Planning Report Date: January 27, 2020

to permit the development of two apartment buildings containing 104 proposed units for affordable, non-market housing.

# Sohkeya Phase 2

## Response to Advisory Design Panel Statement of Review – 14 November 2019

Sheet Title  
**Level 1**

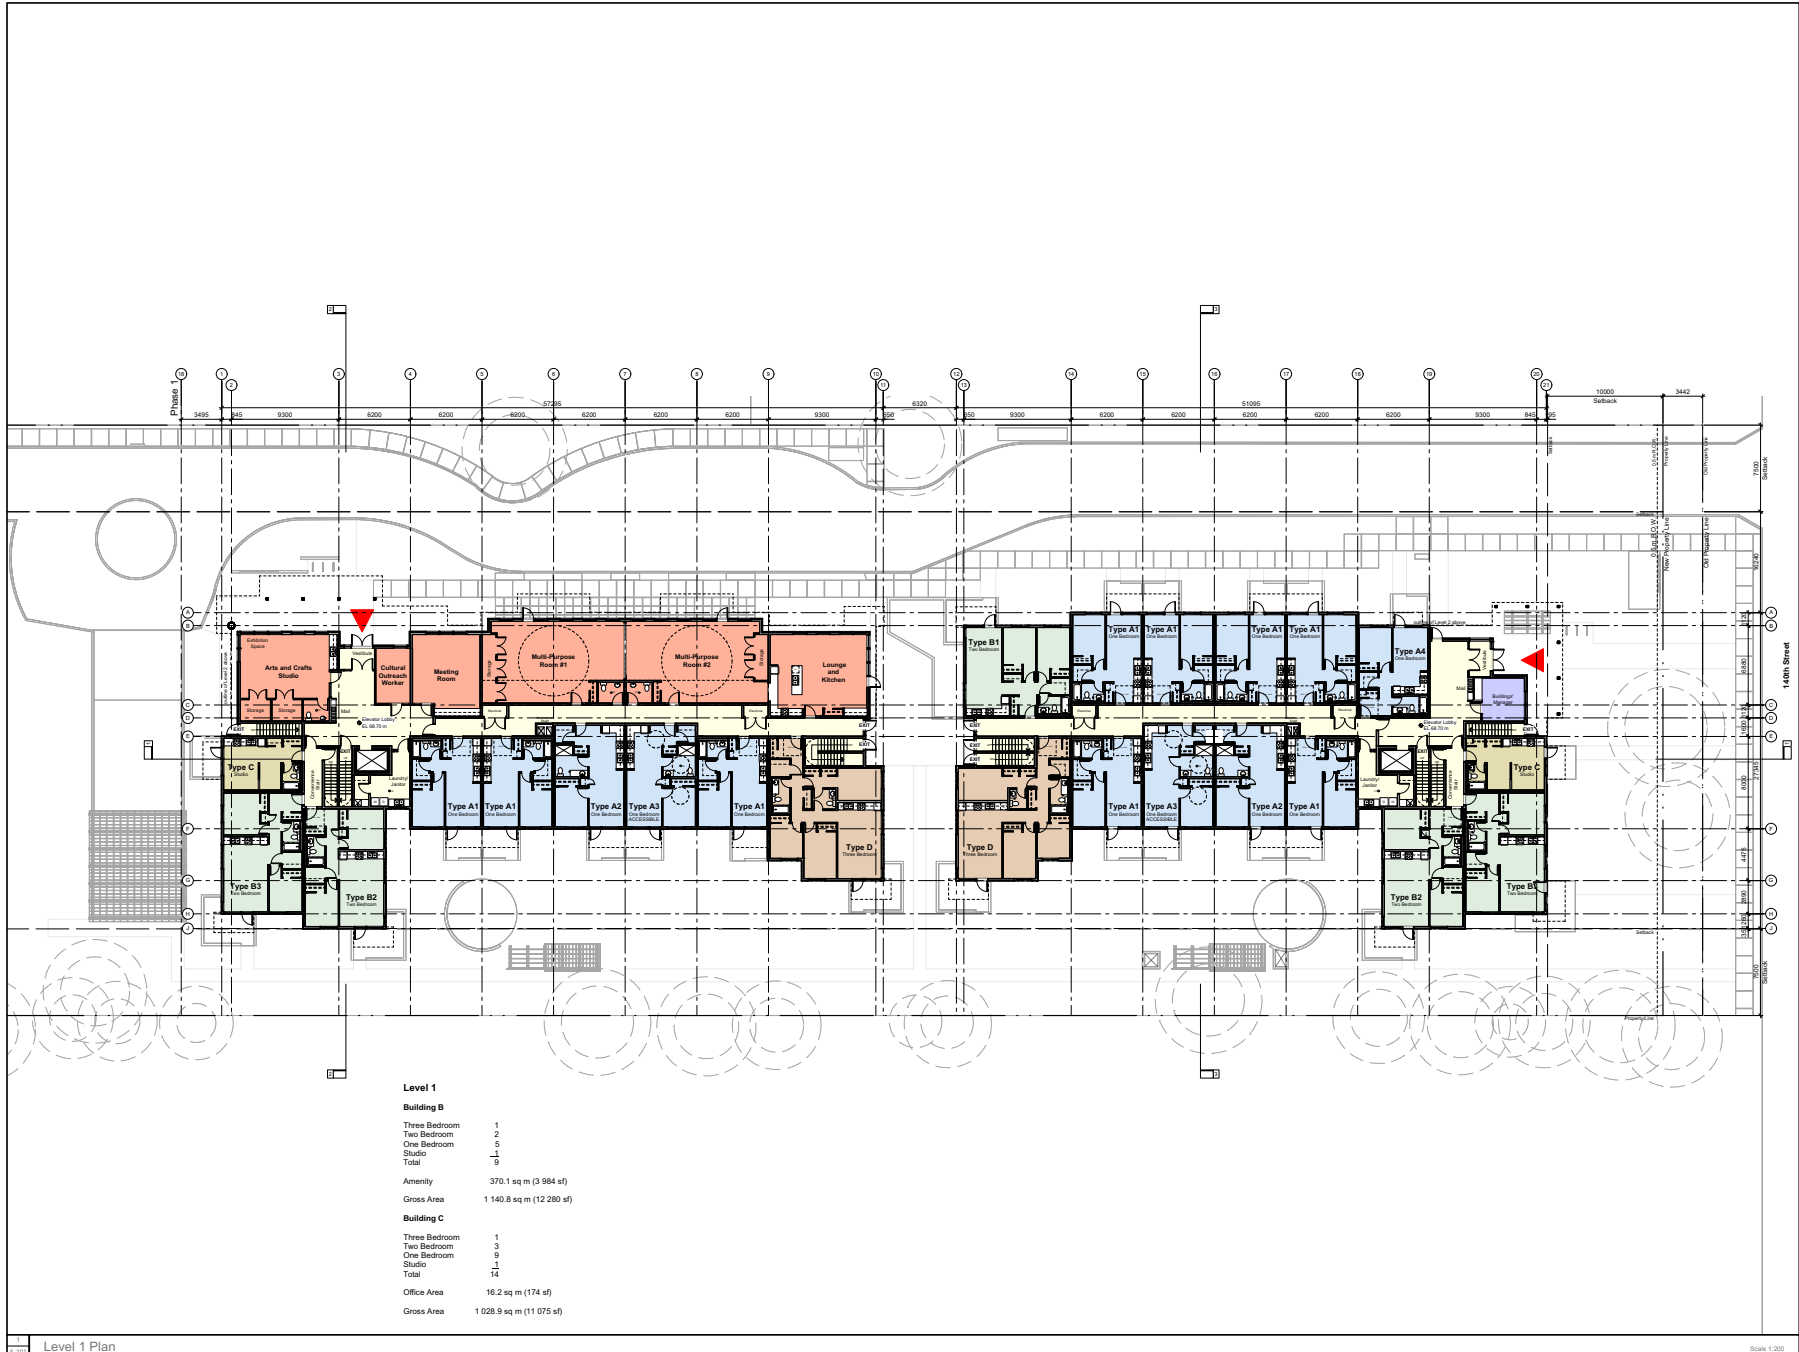
1. Consider locating amenity spaces adjacent to courtyards; opportunity to bring activities to underutilized courtyard spaces. **Client prioritized south facing ground floor units with ample patio space at quieter courtyard spaces. Larger ground floor two and three bedroom units are located adjacent to the courtyards. Amenity spaces and their related activities were preferred along the internal road away from the calmer courtyard spaces.**

7. Consider the relationship with amenity space and access to light. **The production of art in the Arts and Crafts Studio will benefit from north light. Multi-purpose rooms, meeting room, lounge and kitchen have direct views to the heavily forested area of Frank Hurt Park to the north.**

10. Consider increasing openness of arts and crafts studio. **The Arts and Crafts Studio have been re-oriented east-west to take advantage of north light and making it more visible and open to passerbys.**

12. Consider a stronger relationship between Building C and the zone in between the two buildings. **An amenity lounge and kitchen space open to an outdoor terrace (plaza) in the breezeway.**

**Amenity space has been flipped into Building B along the internal road where outdoor space is more limited. North facing ground floor units have been moved to Building C in order to provide deeper patio spaces and a landscape buffer with the internal road.**

Sheet Title  
Elevations

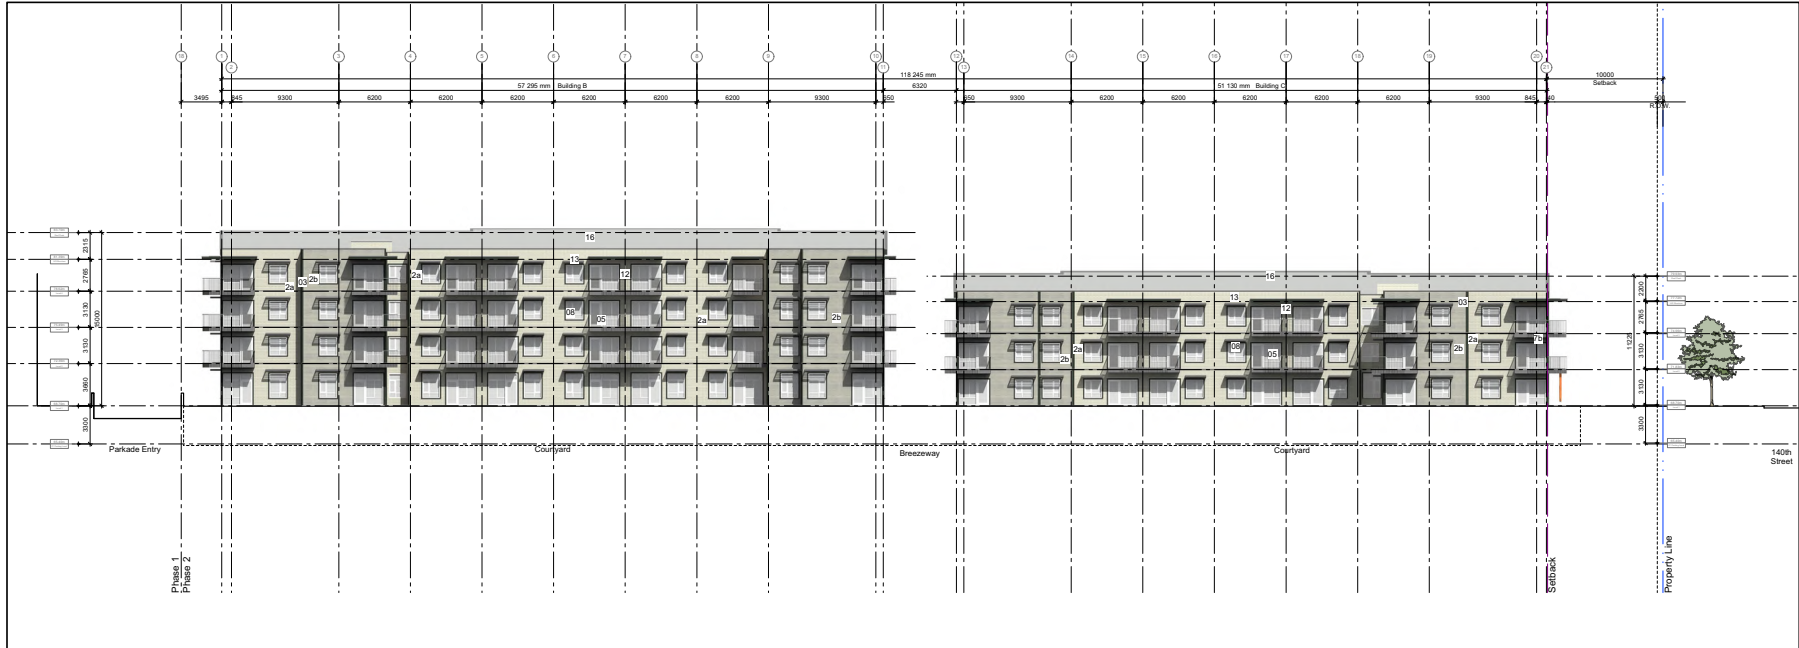
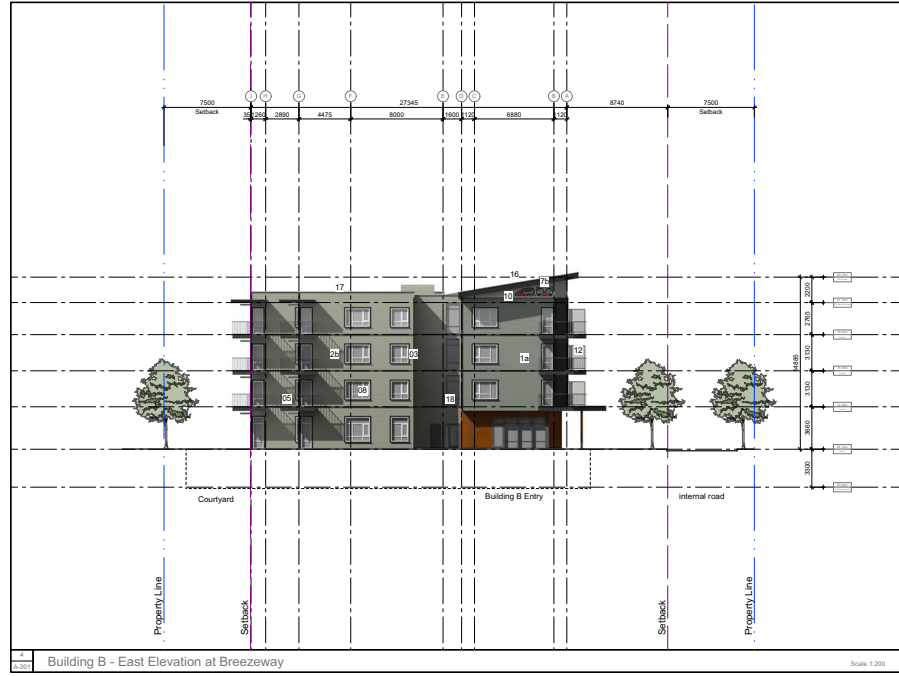
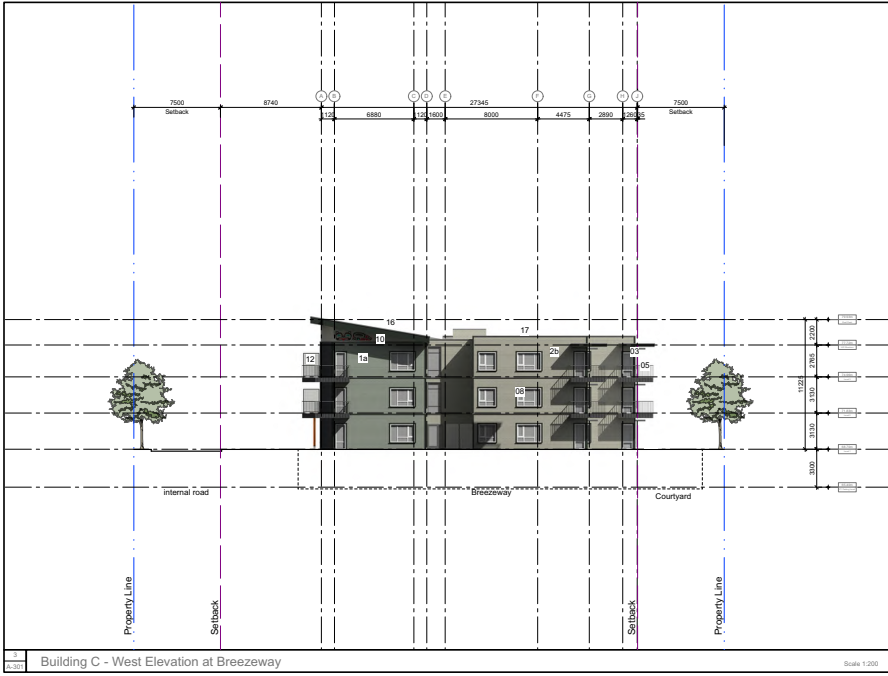
3. Consider larger patios along the south. **Ground level south and north facing patios have been enlarged.**
4. Consider using alternative material or colours along the north and south elevations to create more visual interest. **An additional darker green colour lap siding has been introduced to the middle bays of the north facing facades to create variation.**

18. Commend use of timber at the entries, solar shading and the integration of light at the corridor internally. **No change.**
19. Building C differentiated ground level on north is successful. Suggest this on Building B and other ground levels. **An additional darker green colour lap siding has been introduced to the middle bays of the north facing facades to create variation.**

23. Reconsider northwest elevation and streamlining/refinement arrangement of the balcony, guardrail, solar shade and parapet integration. **No change.**

24. Reconsider relationship between sloped roof fascia and parapet (gridline D). **The sloped roof overhang and the parapet at the flat roof are balanced.**

25. Appreciate the frieze feature and slope roof; however, it is black paint on a dark panel on the north side of a dark building and may be lost. Consider relocating so it can be seen and experienced as intended. **The panel is a placeholder. The intent is to provide an opportunity for an indigenous artist(s) to create artwork to be transferred onto the panels. The content and colour are to be determined.**

Sheet Title  
**LANDSCAPE PLAN - PHASE 2**

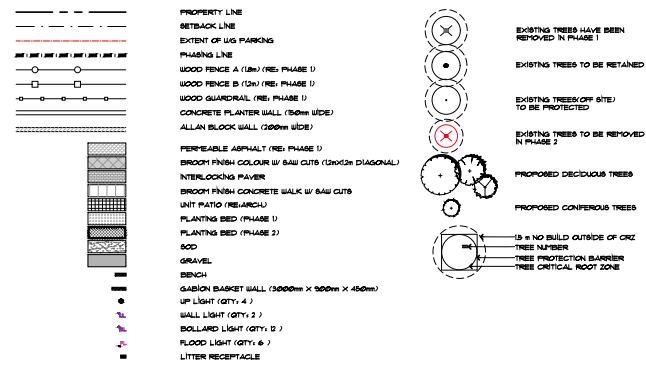
- On the landscape plan, ensure there are no discrepancies between the trees on the plant list and on the plan.
- Concrete planters over slab containing trees should allow for 1 metre depth of growing medium and a volume of 10 cubic metres per tree.

2. Consider moving the playground location from 140 Avenue. **The Children's Play Area(s) have been moved to the underutilized courtyard spaces and away from 140<sup>th</sup> Avenue.**

6. Consider stormwater strategy. **Existing drop-off zone along northside of internal road is permeable for water filtration. Rain gardens are proposed for the boulevards along the southside of the internal road.**

8. Outdoor amenity spaces are cramped at the north; recommend prioritizing the pockets available at the south (although there isn't a view to the park, there is sunlight). **Two south facing terraces with trellis and moveable furniture are provided in the courtyards. Children Play Area(s) are also relocated to south facing courtyards.**

9. Consider relocation of playground and picnic table to south courtyard space with a corresponding change in location of all or part of the interior amenity spaces to provide for a strong indoor/outdoor relationship. **Children Play Area(s) are relocated to south facing courtyards. The proposed picnic table at Building C entry is an opportunity for social engagement. If unsuccessful, the table is not fixed and could re-located or removed.**
